UNITED STATES PATENT AND TRADEMARK OFFICE

10/712,070

Office Action Summary	Application No.	Applicant(s)	
	10/712,070	KASHIYAMA ET AL.	
	Examiner	Art Unit	
	Justin Krause	3682

DETAILED ACTION

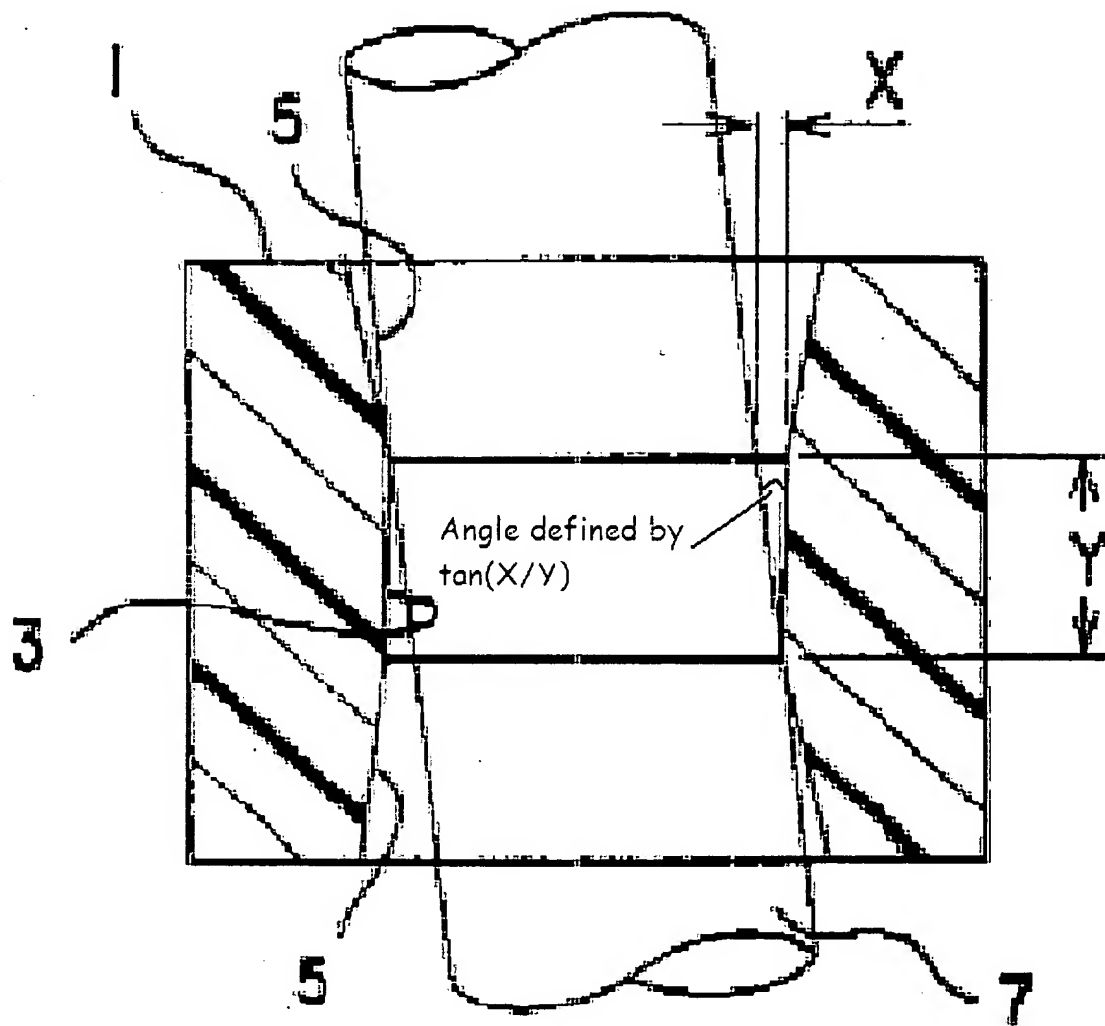
Okada discloses a cylindrical shaped bearing comprising an inner peripheral surface including a first surface (3) parallel to a central axis and second and third tapered surfaces (5) inclined such that the diameters of the second and third tapered surfaces decrease in respective axial directions away from axial ends of the inner peripheral surface toward the first surface.

Regarding claim 3, Okada defines a clearance X, between the shaft and sliding surface (Y) and X/Y is greater than or equal to 0.052, where $\tan(X/Y)$ defines an angle between the central axis of the bearing and the angle of the shaft (see fig below).

At a minimum (i.e. $X/Y=.052$), the inverse tangent of X/Y is 2.97 degrees which defines the minimum possible angle of the second and third surfaces and satisfies the limitation that the angle must be between 0.05 and 5 degrees.
